CITY of NOVI CITY COUNCIL

Agenda Item K
August 28, 2017

SUBJECT: Approval of a request from Etkin, LLC for a variance from Chapter 5, Section 2.2.4 (B)(7) of the Engineering Design Manual to allow the construction of a permanent storm water pump station to service drainage for the proposed Fountain Office Park (A123 Systems) development located south of 12 Mile Road and west of Cabaret Drive, subject to the applicant meeting requirements of said section of the Engineering Design Manual.

Final Site Plan

ORIGINAL ISSUE DATE: JULY 14, 2011
PEA JOB NO: 3818-212
SCALE: 1" = 40'
DRAWING NUMBER: C-7.1

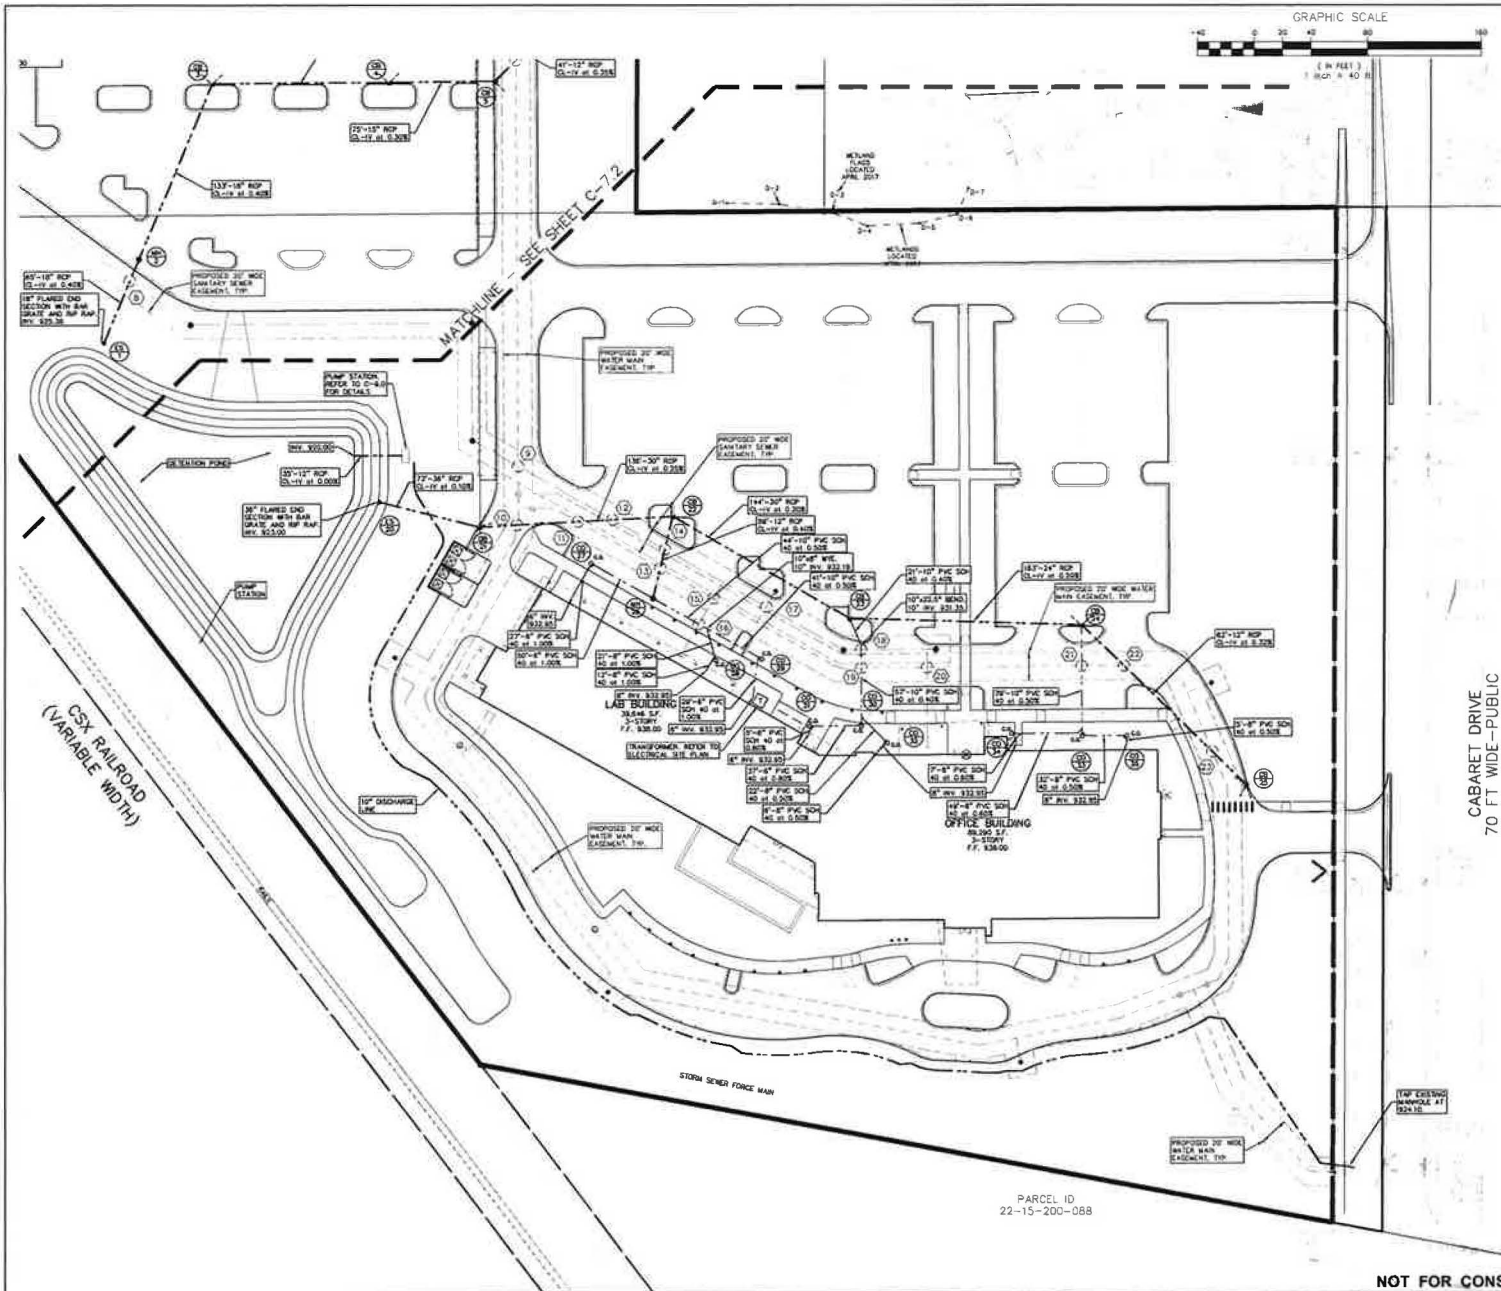
21. A storm water agreement/detention basin agreement is required.
22. Match the 0.80 diameter depth above invert for pipe size increases.
23. Sheet C-5.1: The existing curb-type pavement catch basin located on the proposed south drive approach must be replaced by a non-curb type cover.
24. Sheet C-7.1: Note the length, material, class/type of the proposed 10" discharge line.

DATE: JULY 14, 2011
 DRAWING NUMBER: C-5.1

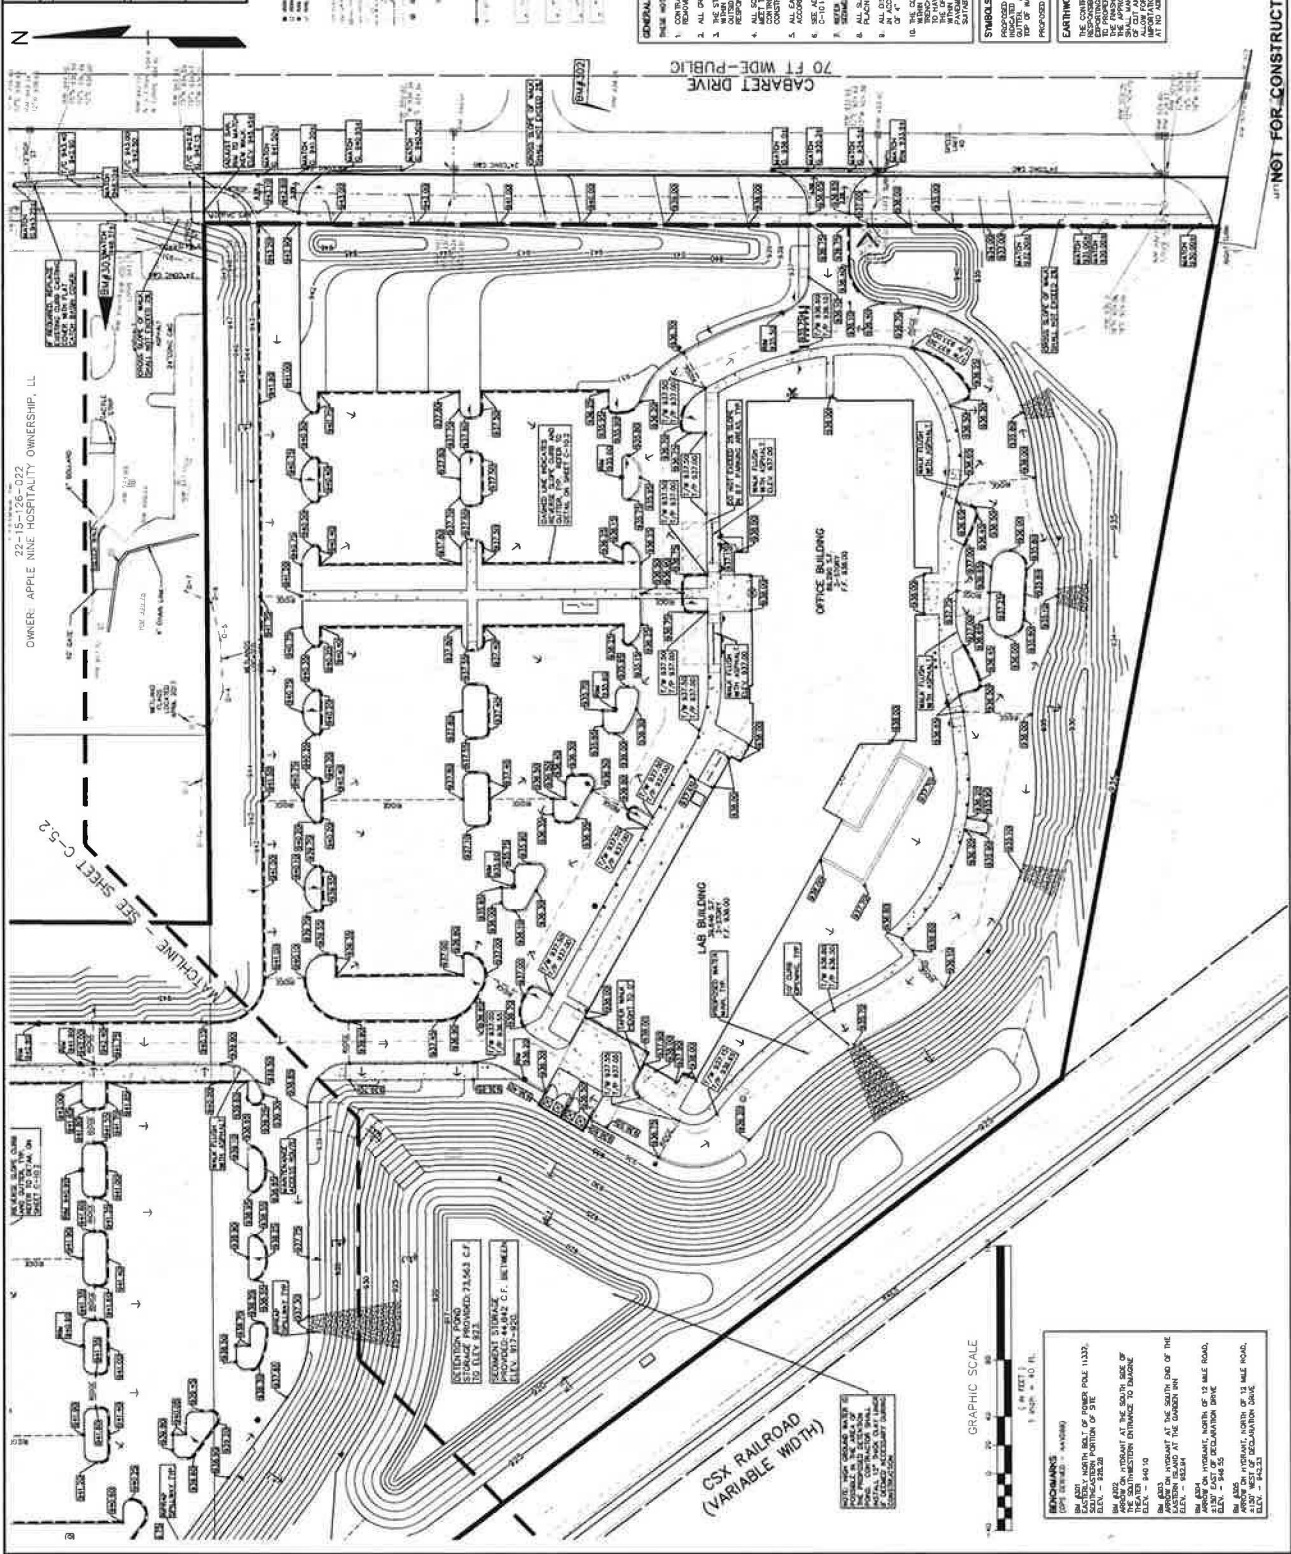
31. Sheet C-5.1: Per Section 11-93 of Chapter 11 of the City of Novi Codified Ordinance, underground drainage facilities will be required for storm water disposal system; i.e., the runoff directed into the 4 spillways in the south side must be caught by storm structures. The same applies for the other 2 spillways to the north of the detention pond. These 2 spillways can potentially erode the north bank of the basin.

DATE: 06/11/2014
 SCALE: 1" = 40'
 DRAWING NUMBER: C-7.2

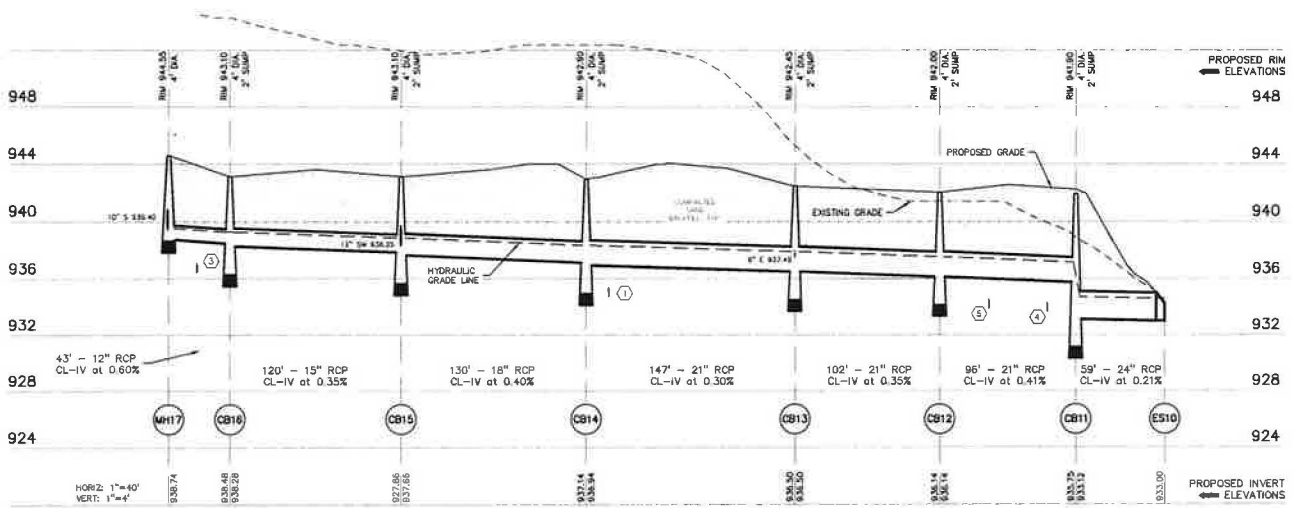
33. Sheet C-7-2: End Section ES10 must be connected to the detention basin. Limit number of inlets to the basin by combining End Section ES10 and ES1 to just one inlet.

DRAWING NUMBER
C-8.1

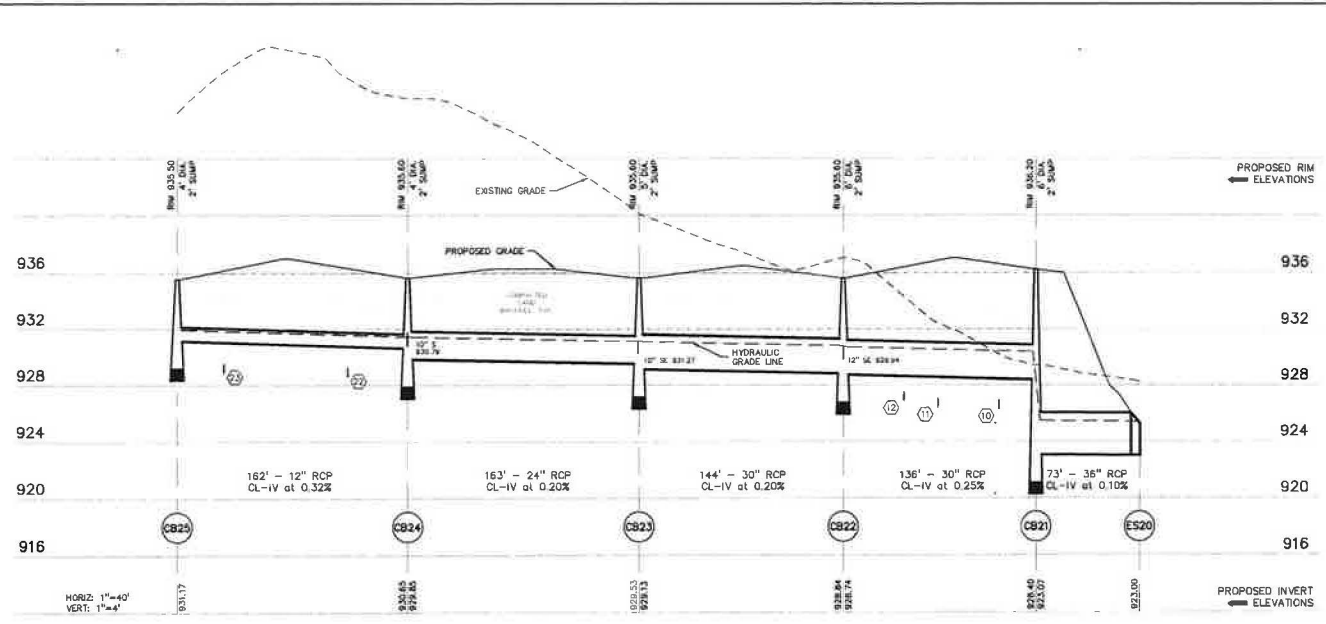
25. Sheet 8.1: Note on profile: Grade must be built up to approximate proposed elevation prior to installation of storm sewer between Structures ES10 and CB12. The same applies to storm sewer between Structures ES1 and CB4.

34. Sheets C-8.1 and 8.2: Note and show the riprap for the Inlet and outlet at the detention basin. Include detail on the plans.
